**Project/File: Barber Mill Estates (CAR13-00007 & PUD13-00002)**

The applicant is requesting approval of an annexation and rezoning for a Planned Unit Development. This subdivision will feature 47 residential lots and 10 common lots on approximately 12 acres located at 5237 E Sawmill Way in Boise, Idaho.

Lead Agency: City of Boise

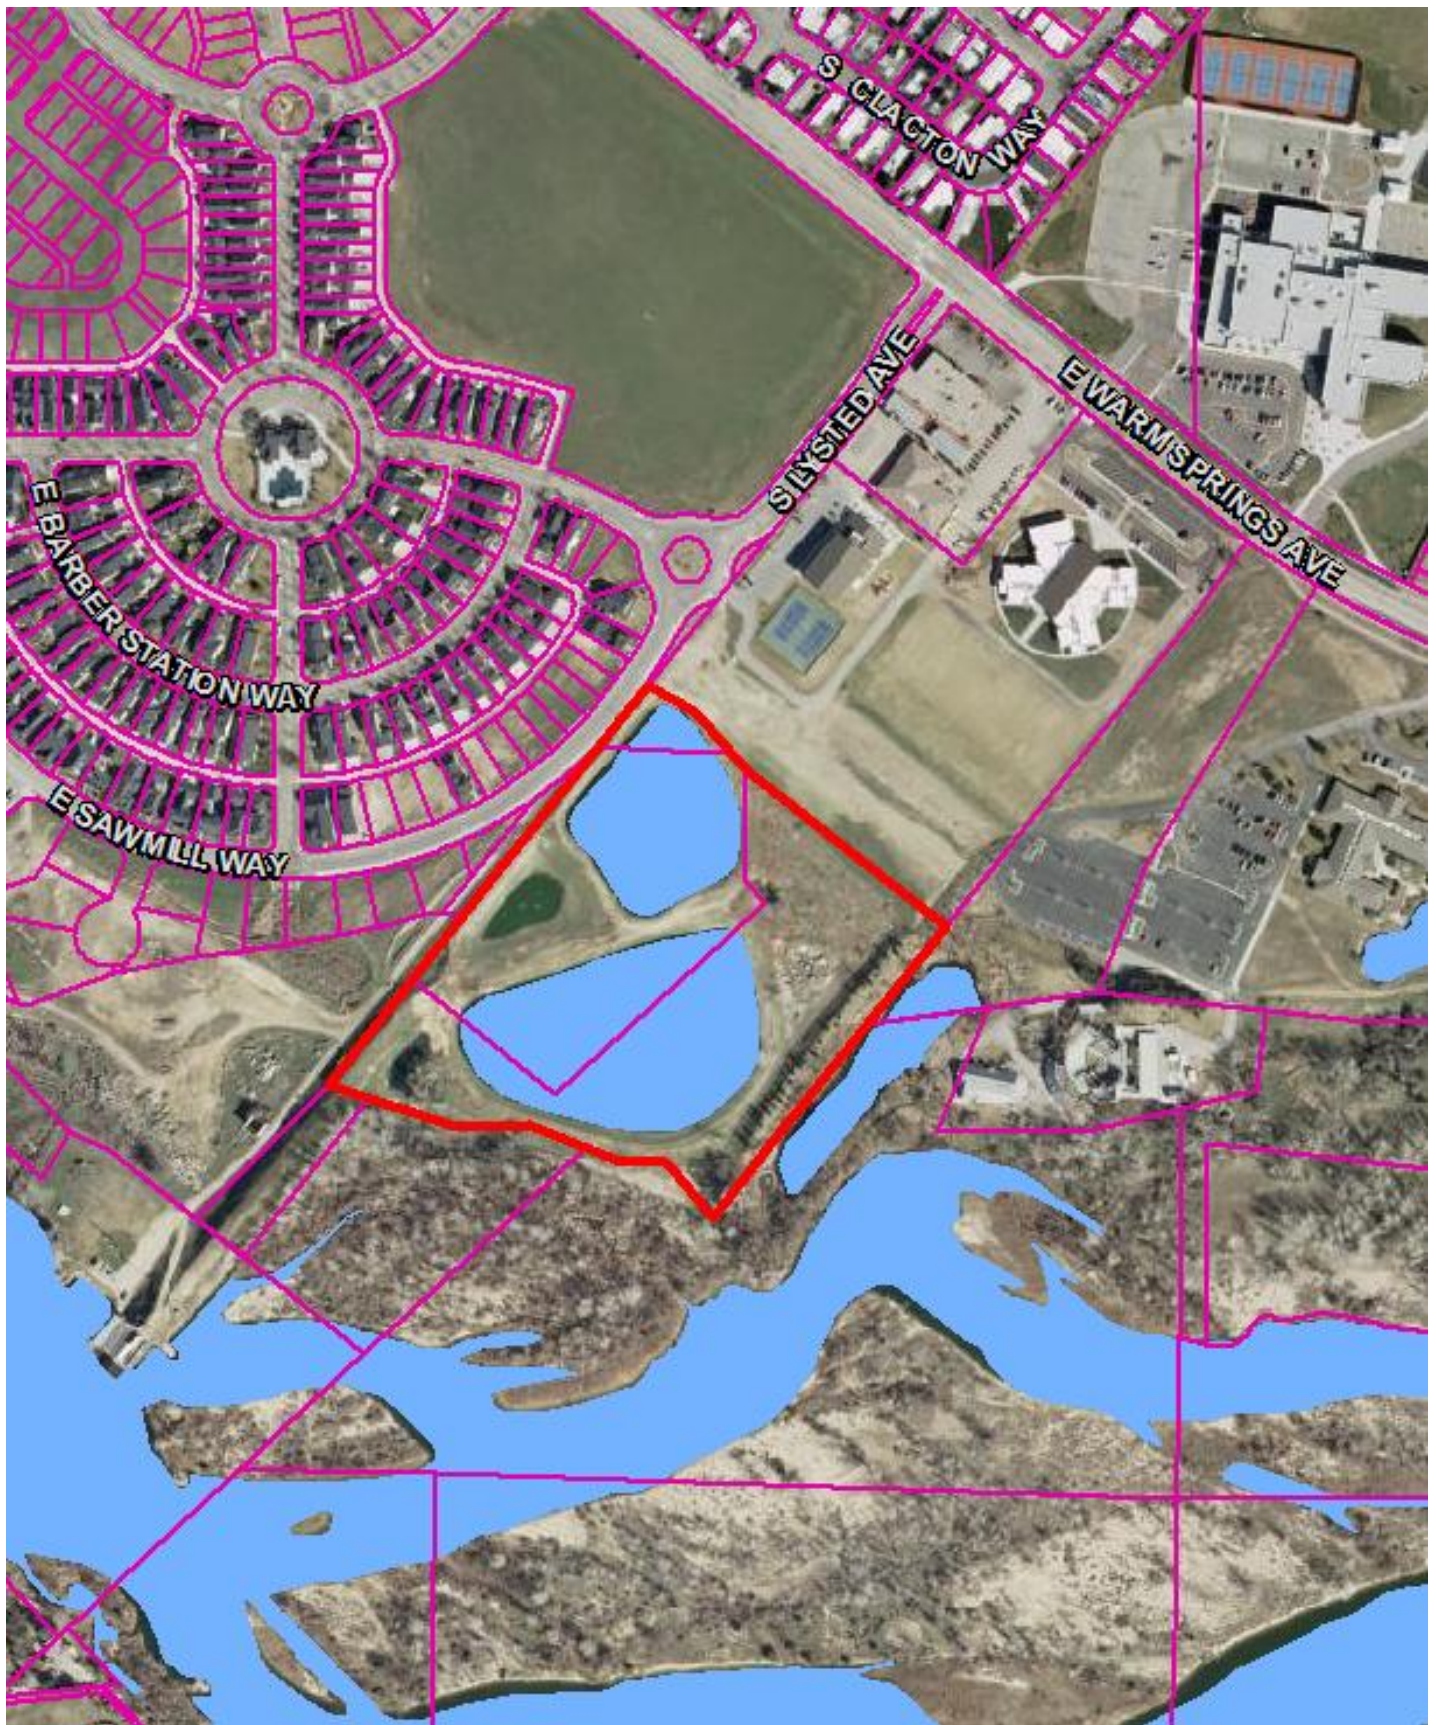
- Vertical curbs are required around the perimeter of any raised median. Gutters shall slope away from the curb to prevent ponding.
- c. **Applicant's Proposal:** The applicant is proposing to construct the entry road into the site with two 23 foot wide travel lanes, a 10 foot center landscape island, curb, gutter, and a 5 foot attached concrete sidewalks within 70 feet of right of way. The applicant is proposing to construct all other internal local streets as 36 foot street sections with curb, gutter, and 5 foot wide attached concrete sidewalks within 50 feet of right of way.

- d. **Staff Comments/Recommendations:** The applicant's proposal meets District policy and should be approved as proposed. The applicant should be required to dedicate the center landscape island as right of way, owned by ACHD. The applicant or the future homeowners association should enter into a license agreement with the District for landscaping within the center landscape island.
